WASHINGTON STATE  
DEPARTMENT OF TRANSPORTATION  
CHANGE ORDER

CONTRACT NO: 009600 FEDERAL AID NO:  
CONTRACT TITLE: US 395, NSC SPRAGUE AVE TO SPOKANE RIVER PHASE 1  
CHANGE ORDER NO: 3 VECP SPREAD FOOTING

CHANGE ORDER NO: 3

This Work consists of deleting Bid Item #5, REMOVING SHAFT OBSTRUCTIONS, Bid Item #10, CONSTRUCTING 10 FT DIAM. SHAFT, and Bid Item #12 QA SHAFT TEST, by the Contractor's proposal per Section 1-04.4(2). Added Work, Contractor's Engineering Costs, and Incentive Payment shall be per the contractor's proposal as shown in Section 1-04.4(2), Value Engineer Change Proposal

**FOOTING PLAN**  
PIERS 2, 3, 5, 6, 8 AND 9

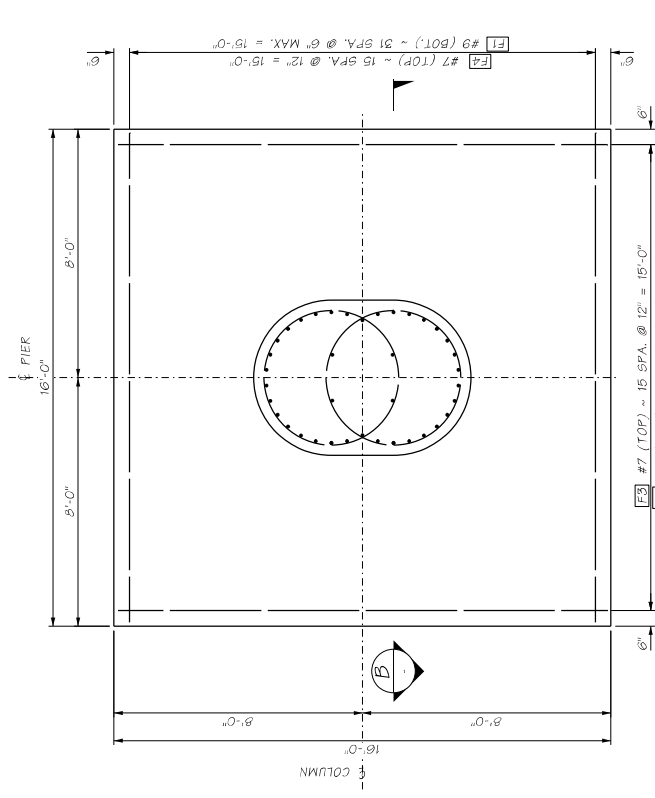
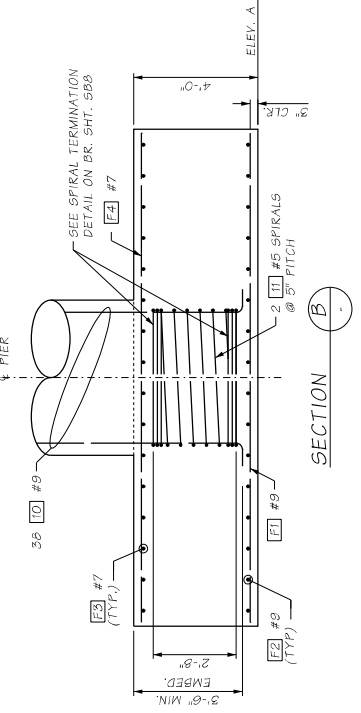
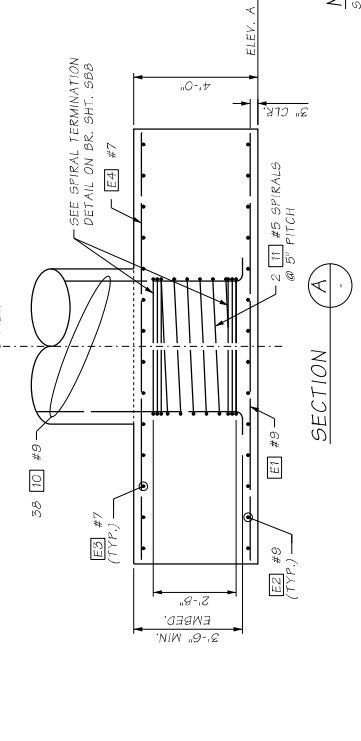
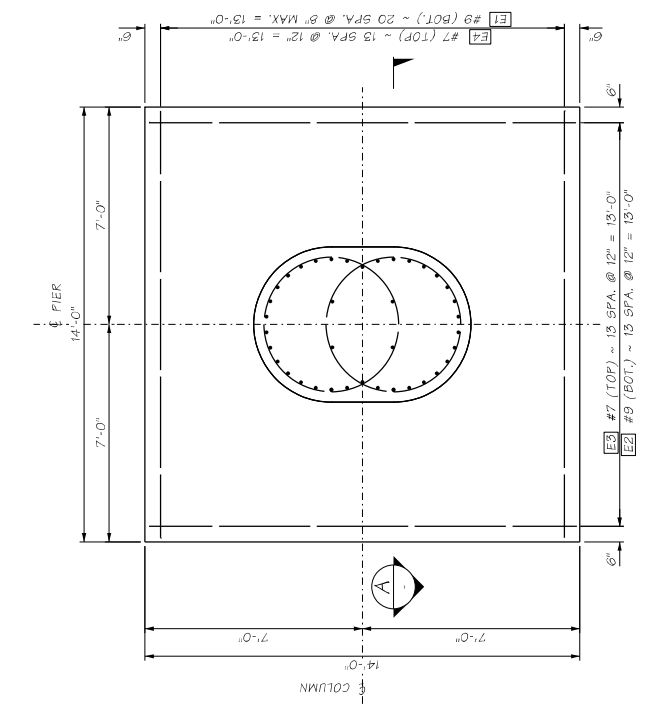
The construction requirements of Section 2-09 and 6-02 shall apply. The Contractor accepts design risk of the foundation footings; everything below the top of the footings, both temporary and permanent of the changed Work. The Contractor provides the Contracting Agency with the right to use all or any part of the proposal on future projects without further obligation or compensation.

NOTE:  
SPREAD FOOTINGS SHALL BE CONCRETE CLASS 4000

FOUNDATION LAYOUT  
BEARING OF PIERS ARE NORMAL TO LR LINE

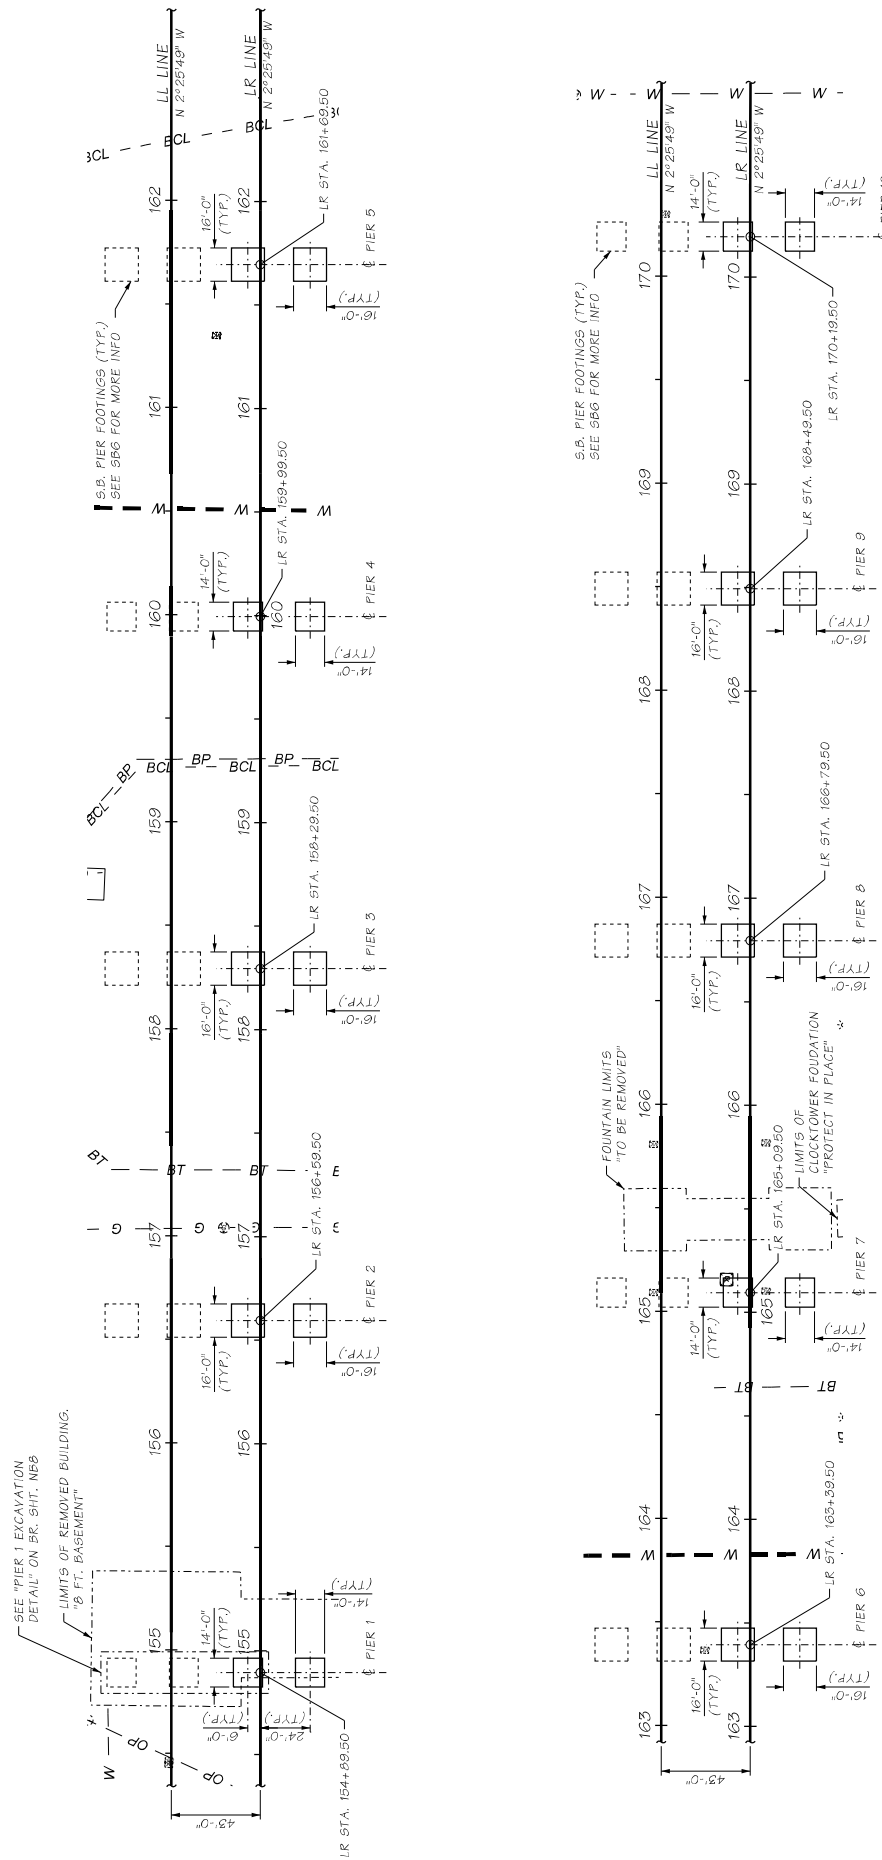
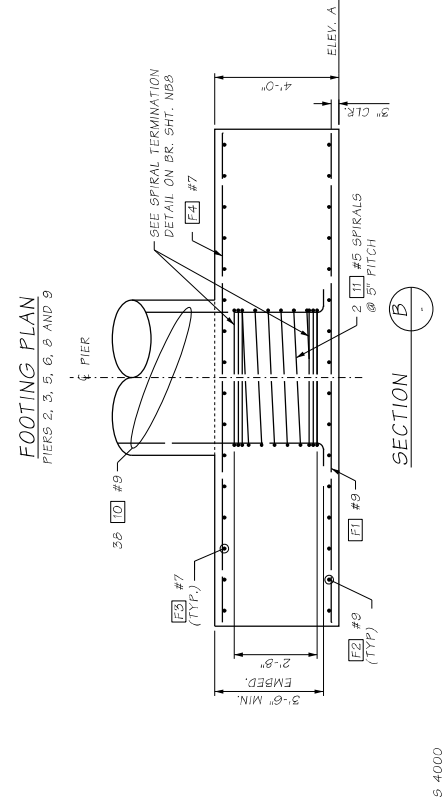
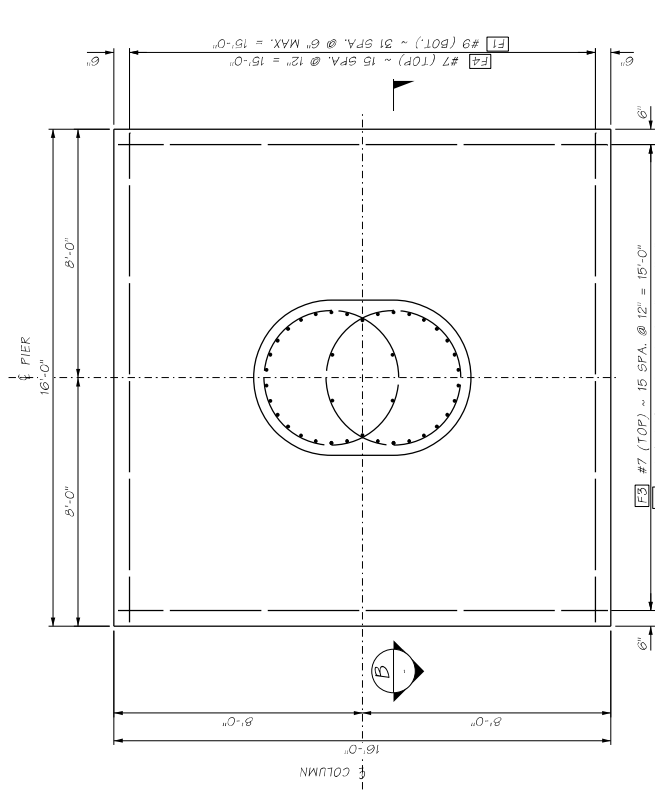
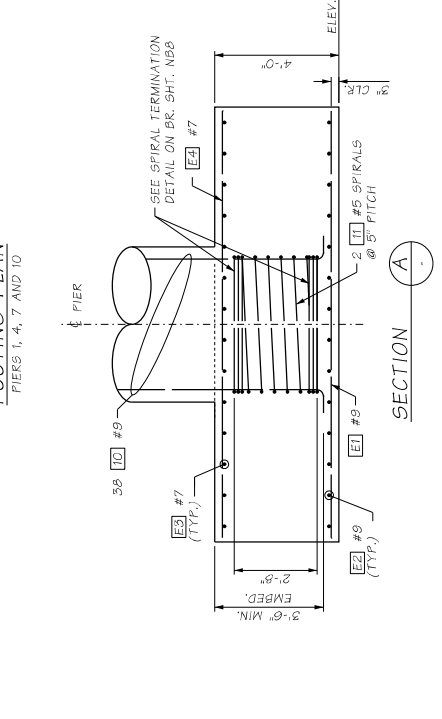
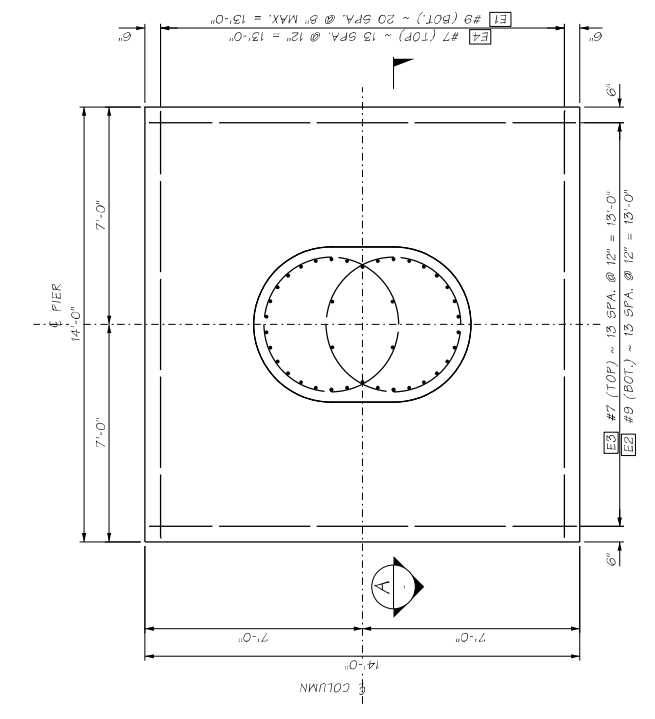
NOTE:  
SPREAD FOOTINGS SHALL BE CONCRETE CLASS 4000

**PIER 1 EXCAVATION DETAIL**

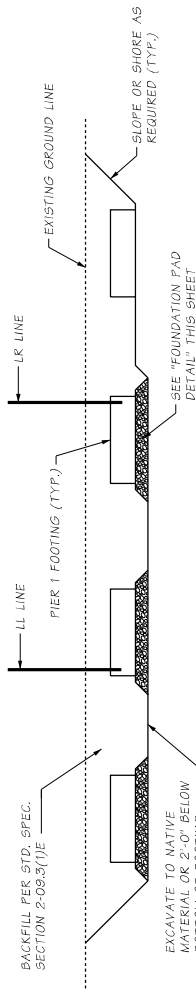
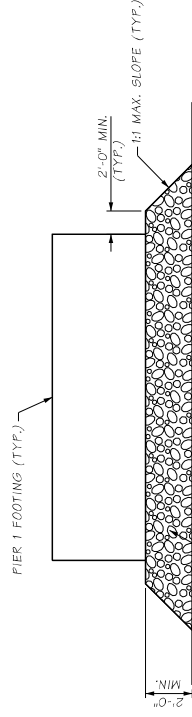
**FOUNDATION PAD DETAIL**  
 FOUNDATION PAD SHALL CONSIST OF EQL. TIEBOLTS FROM ADJACENT FOOTING EXCAVATIONS PROVIDED THEY MEET THE GRADATION REQUIREMENTS OF SELECT BORROW IN ACCORDANCE WITH STD. SPEC. SECTION 9-03.14(2). UNSUITABLE MATERIAL OR MATERIAL NOT MEETING THE GRADATION REQUIREMENTS FOR SELECT BORROW TO BE WASTED. FOUNDATION PAD TO BE COMPACTED IN ACCORDANCE WITH STD. SPEC. SECTION 2-03.3(14)C, METHOD C.
